MISROUTED WIRING WARRANTS WARRANTY

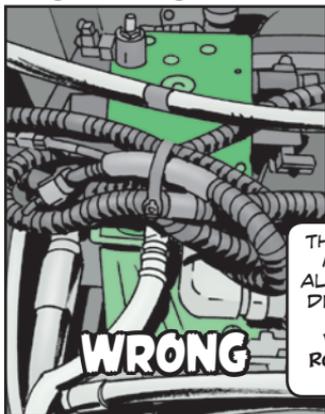
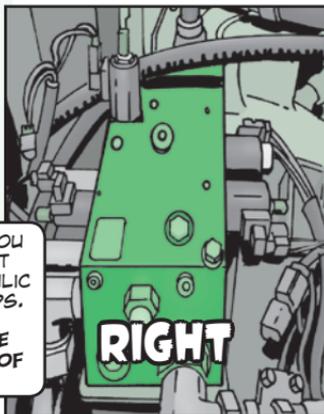
A manufacturing error resulted in the wiring harnesses being routed directly across the top of the hydraulic distribution manifold in some HEMTT -A4 trucks. Routed this way, the wiring harness might start a fire.

THE SOLUTION IS FOR YOU MECHANICS TO INSPECT ALL HEMTT -A4 HYDRAULIC DISTRIBUTION MANIFOLDS. MAKE SURE THAT NO WIRING HARNESSES ARE ROUTED OVER THE TOP OF THE MANIFOLD.

If you find any, contact Oshkosh Corporation to schedule the vehicle for repair. They're at: WarrantyClaims@defense.oshkoshcorp.com

Oshkosh will provide the required parts and labor to fix the trucks at no cost to your unit. They'll repair the vehicles as part of a retrofit effort that includes rerouting the wiring harnesses.
